Access Compliance Report Public Rights-of-Way (Curb Ramps)

Main Street: HARHAY_AVE **Cross Street:** PACIFIC_ST **Location:** SE

ADA ID: RPRK211005173127 **Ramp Type:** Type 1 - Perpendicular Diagonal Initial Pass/Fail: Fail **Overall Compliance:** No **Severity Score:** 30

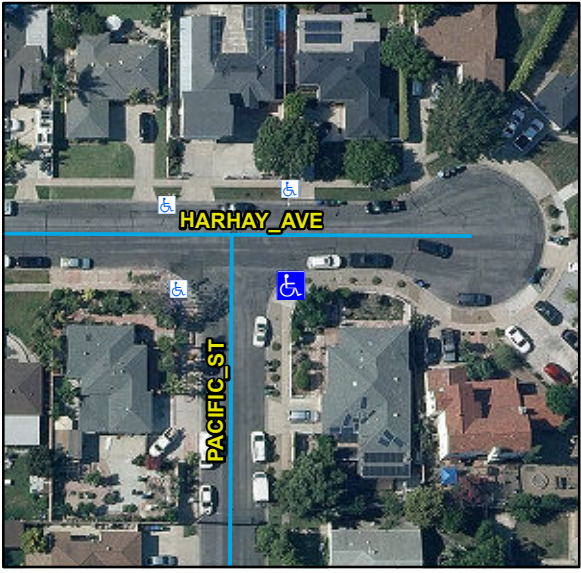
Compliance	Description	Data	Compliance	Description	Data
N/A	Ramp Length (in)	83	N/A	Flare Type LT	
Yes	Ramp Width (in)	48			N/A
No	Ramp Run Slope (%)	14.5	N/A	Flare Slope LT (%)	N/A
Yes	Ramp Cross Slope (%)	1	N/A	Flare Traversable LT	N/A
N/A	Landing Present	N/A	N/A	Flare Type RT	
N/A	Landing Length (in)	N/A			N/A
N/A	Landing Width (in)	N/A	N/A	Flare Slope RT (%)	N/A
N/A	Landing Run Slope (%)	N/A	N/A	Flare Traversable RT	N/A
N/A	Landing Cross Slope (%)	N/A	N/A	DWS Provided	N/A
N/A	Landing Movement Obstructed?	N/A	N/A	DWS Contrast	N/A
	Landing Movement Type	N/A	N/A	DWS Length (in)	N/A
N/A	Landing Shared	N/A	N/A	DWS Full Width	N/A
N/A	Clear Space	Yes	N/A	DWS Offset Left (in)	N/A
N/A	Clear Space To Crosswalk (in)	N/A	N/A	DWS Offset Right (in)	N/A
N/A	Marked Crosswalk 1	No	N/A	Marked Crosswalk 2	No
	Crossing 1 Direction	N		Crossing 2 Direction	W
	Marked Crosswalk 1 Width (in)	N/A		Marked Crosswalk 2 Width (in)	N/A

Possible Solutions:
Remove & Replace Curb Ramp With Two New Directional Ramps or Equivalent.

OC Std/PROW:
 R304.2.2, STD 1115
